APPLICATION NO.	FILING DATE	FIRST NAMED INVENTOR	ATTORNEY DOCKET NO.	CONFIRMATION NO.	
09/727,839	11/30/2000	Ashok Machcha	Q00-1017-US1	3918	
7	590 08/01/2002				
TEJPAL S. HANSRA			EXAMINER		
3705 CANTER	RENT SERVICES RBURY LANE, #6		WATKO, JU	LIE ANNE	
BELLINGHAI	M, WA 98225		ART UNIT	PAPER NUMBER	
			2652		
			DATE MAILED: 08/01/2002	DATE MAILED: 08/01/2002

100				
		Application No.	Applicant(s)					
		09/727,839	MACHCHA ET AL.					
	Office Action Summary	Examiner	Art Unit					
		Julie Anne Watko	2652					
The MAILING DATE of this communication appears on the cover sheet with the correspondence address Period for Reply								
A SH THE - Exte afte - If th - If No - Fail - Any	HORTENED STATUTORY PERIOD FOR REPL' MAILING DATE OF THIS COMMUNICATION. ensions of time may be available under the provisions of 37 CFR 1.13 or SIX (6) MONTHS from the mailing date of this communication. e period for reply specified above is less than thirty (30) days, a reply op period for reply is specified above, the maximum statutory period v ure to reply within the set or extended period for reply will, by statute, reply received by the Office later than three months after the mailing the patent term

Mihara et al Fig. 5, annotated detail

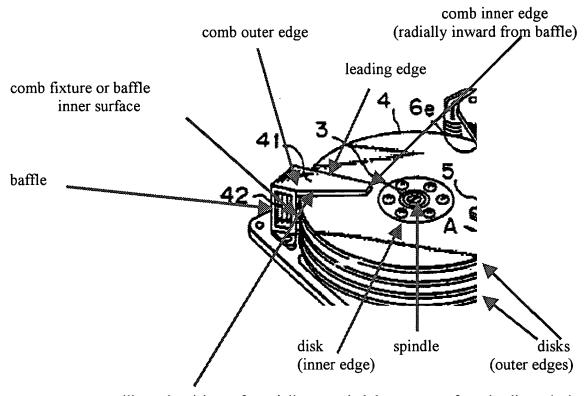
trailing edge (circumferentially extended downstream from leading edge)

fixture (including 42) disposed apart from the actuator assembly 6, and having an inner surface separated by a first distance from the outer edges of the disks 4; combs 41 coupled with and extending inwardly from the comb fixture, at least one of the combs 41: disposed adjacent to a corresponding adjacent disk 4 to provide a gap between the comb 41 and the corresponding adjacent disk 4, the gap disposed in the direction of the spindle longitudinal axis; and extending circumferentially (see Fig. 5 annotated detail) around the spindle longitudinal axis.

As recited in claim 19, Mihara et al show a comb assembly for reducing cross-track motion in a disk drive, the disk drive including at least one disks 4, a spindle 3, and at least one slider assembly (including 8), the comb assembly comprising: at least one baffle (in which 42 is located) disposed upstream of the slider assemblies, the baffle having an inner surface (see Fig. 5 annotated detail) disposed outside of outer edges of the disks 1; and at least one comb 41 mounted on the baffle, wherein each comb 41: is disposed adjacent to at least one of the disks 4 to provide a gap between the comb 41 and a corresponding adjacent disk 4, the gap disposed in the direction of a spindle longitudinal axis; extends radially inward from a comb outer diameter (see comb outer edge in Fig. 5 annotated detail), the comb outer diameter disposed approximately at the inner surface of the baffle; disposed upstream (see R direction in Fig. 1) of the slider assemblies (including 8); extending in a disk circumferential direction from a leading edge to a trailing edge, the leading edge disposed upstream of the trailing edge; and extending radially inward from the baffle (see Fig. 5 annotated detail).

As recited in claim 4, Mihara et al show a second set of combs (arbitrarily choose one of the four combs 4; the remaining combs constitute a second set of combs) extending radially inward from an outer attachment element inner surface (see baffle inner surface in Fig. 5 annotated detail), the outer attachment element inner surface having a diameter not less than the outer edge of the disks 4, each of the second set of combs: disposed in a position adjacent at least one of the disks 4 in the direction of the spindle 3 longitudinal axis ("A baffle plate 41 is disposed corresponding to each of the four magnetic discs 4 facing the upper surface thereof", see col. 4, lines 41-43); and disposed downstream (please note that each comb 41 is located simultaneously upstream and downstream of the slider assemblies, due to the cyclical nature of the disk rotation and airflow) of the slider assemblies (including 8).
